MATERIALS LICENSE

Amendment No. 05

Licensee	In accordance with letter dated May 7, 1993,	
1. Trijicon, Inc.	3. License Number 21-19874-02E is amended in its entirety to read as follows:	
2. 49385 Shafer Avenue Wixom, Michigan 48393-2869	4. Expiration Date March 31, 1995 (Deemed Timely)	
	5. Docket or Reference No. 030-20771	
6. Byproduct, Source, and/or Special Nuclear Material	7. Chemical and/or Physical Form	8. Maximum Amount that Licensee May Possess at Any One Time Under This License
A. Hydrogen-3	A. Sealed light sources (Saunders-Roe Model PRH 880/G/200 or MB Microtec A.G. Model 400 Series)	A. Not applicable (see Condition 10)

License Number 21-19874-02E

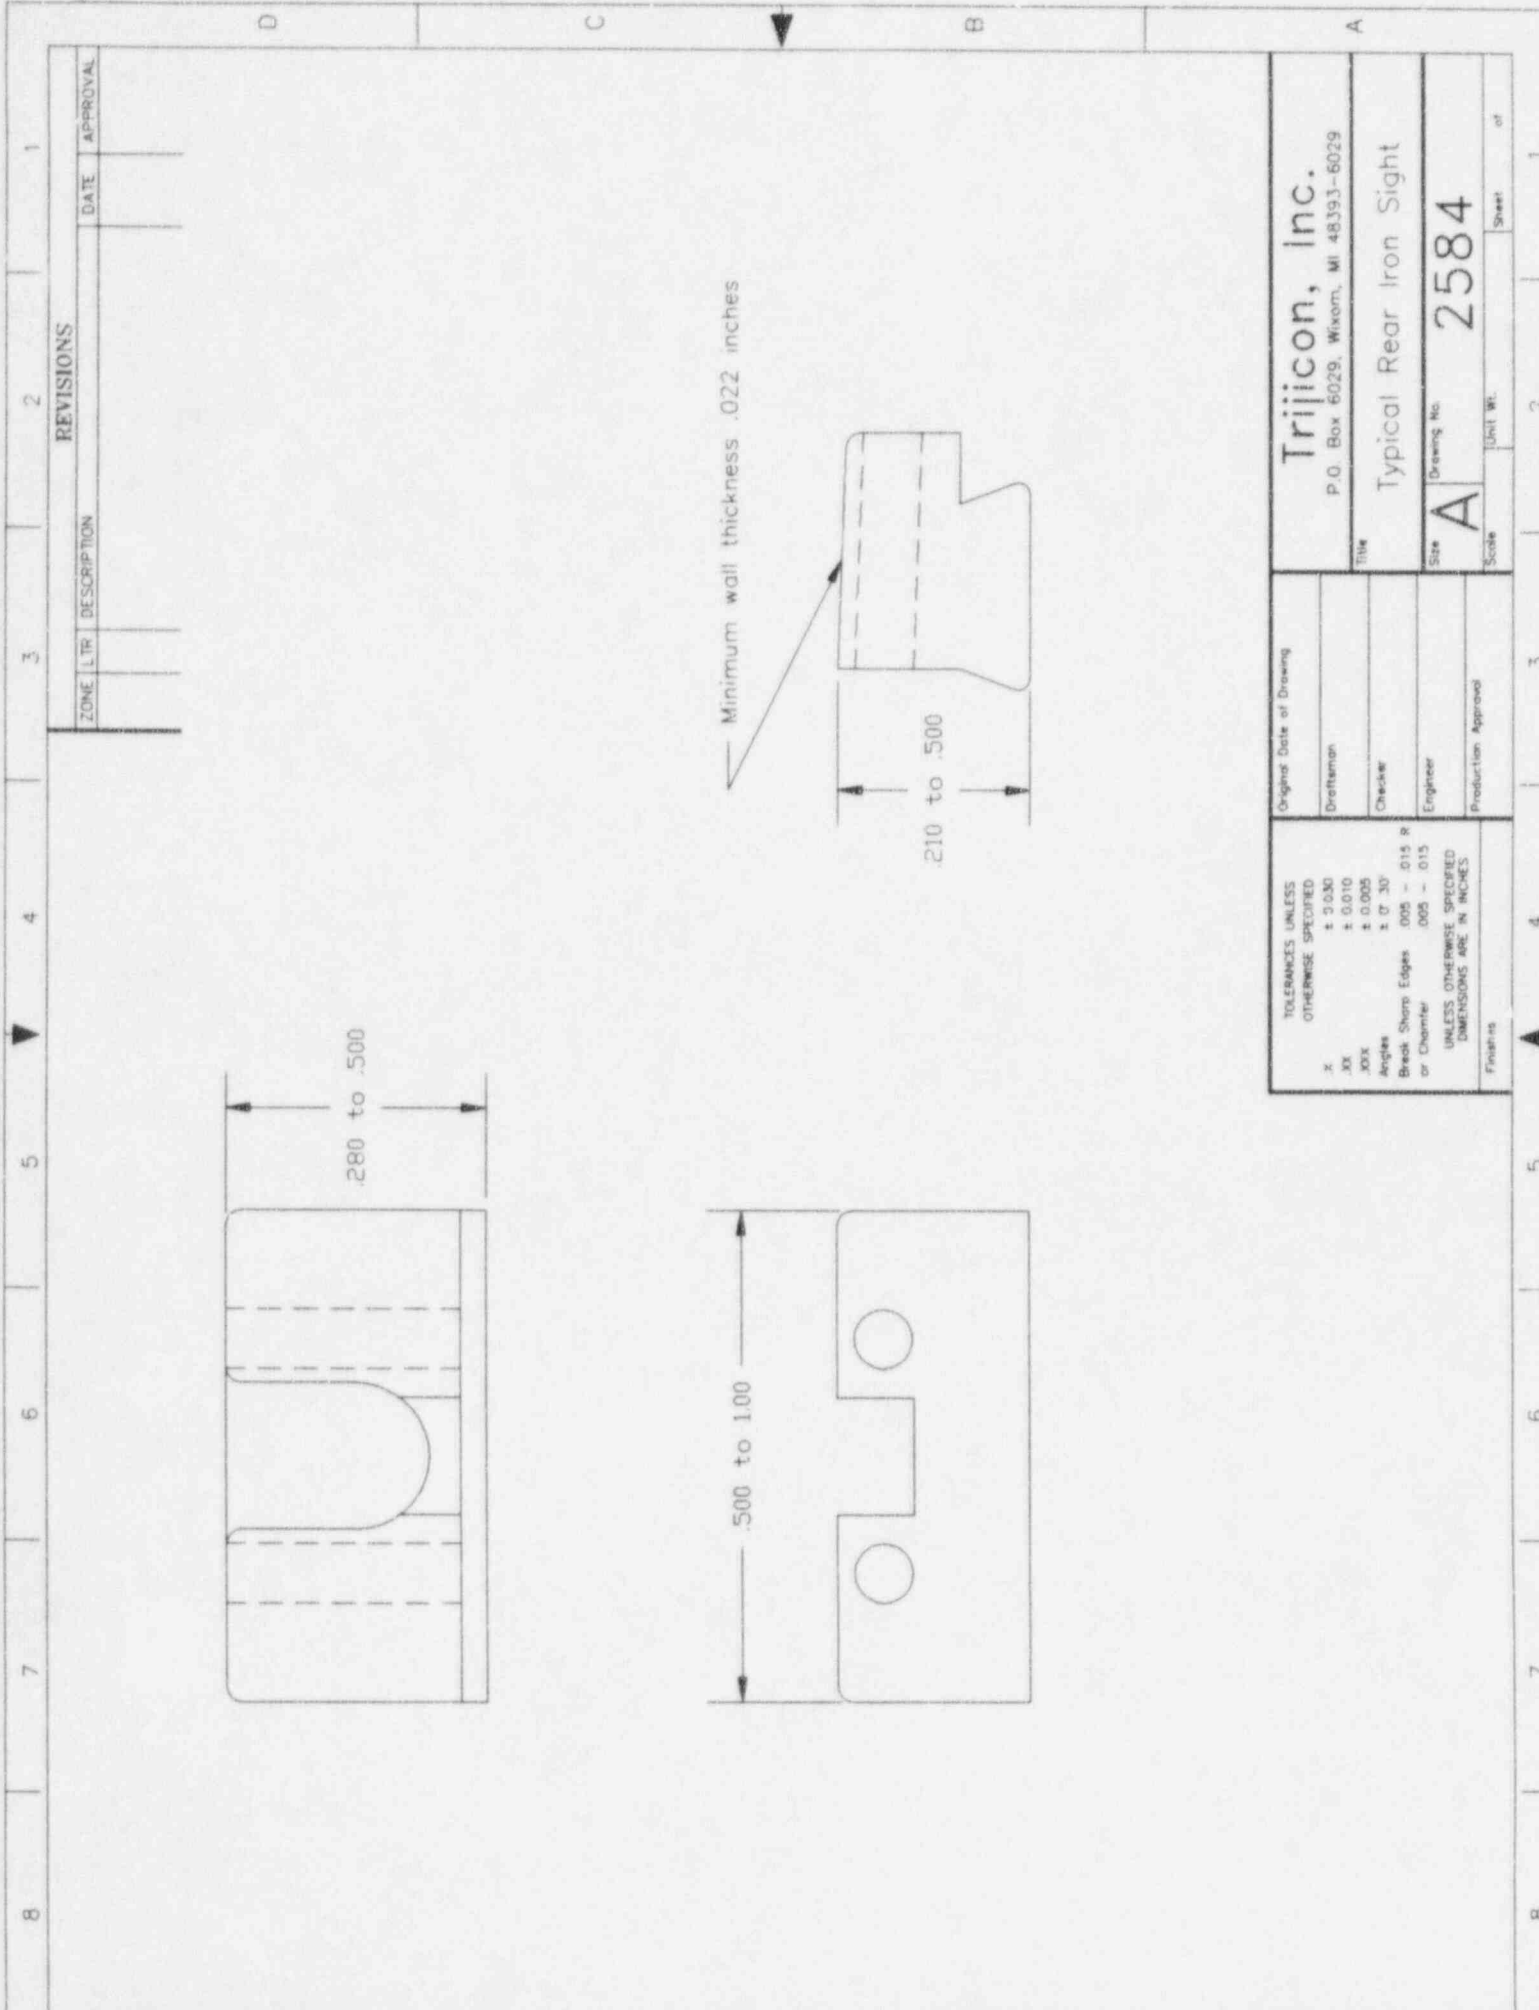
Our drawing #2489 (copy attached) shows a cutaway view of a typical rear sight blade on the right-hand side of the drawing. Our drawing #2584 shows a typical sight with dimensions.

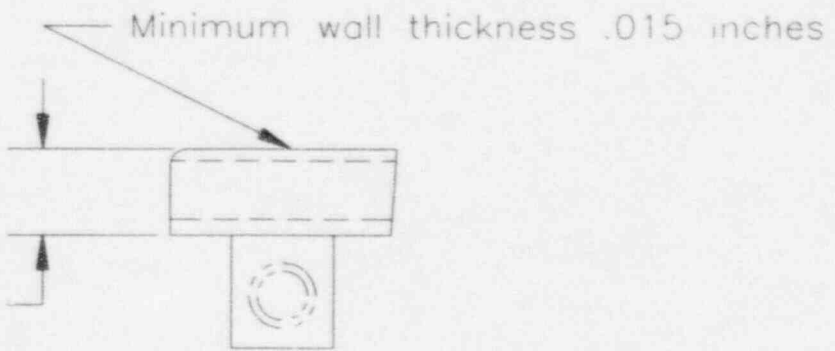
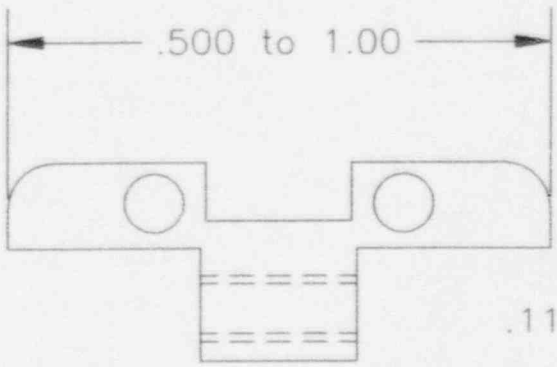
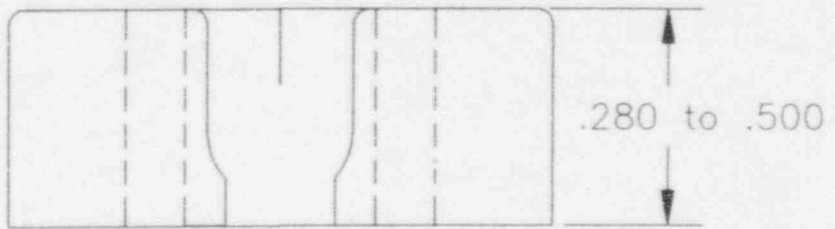
Our drawing #2585 shows a typical sight with dimensions.

Rear sight series (dot) - a block of steel or aluminum with a notch traversing the narrow dimension, containing either two tritium light sources mounted on either side of the notch, or one tritium light source mounted under the notch. The light source(s) are oriented so that the light source is viewed from the end, through a sapphire window at the end of the source. The sight is attached to the weapon by either a press fit into a dovetailed groove, or by an adjustable screw. Maximum content for this series is 60 millicuries per sight. Drawings No. 2584 & 2585 define the physical envelope for this design.
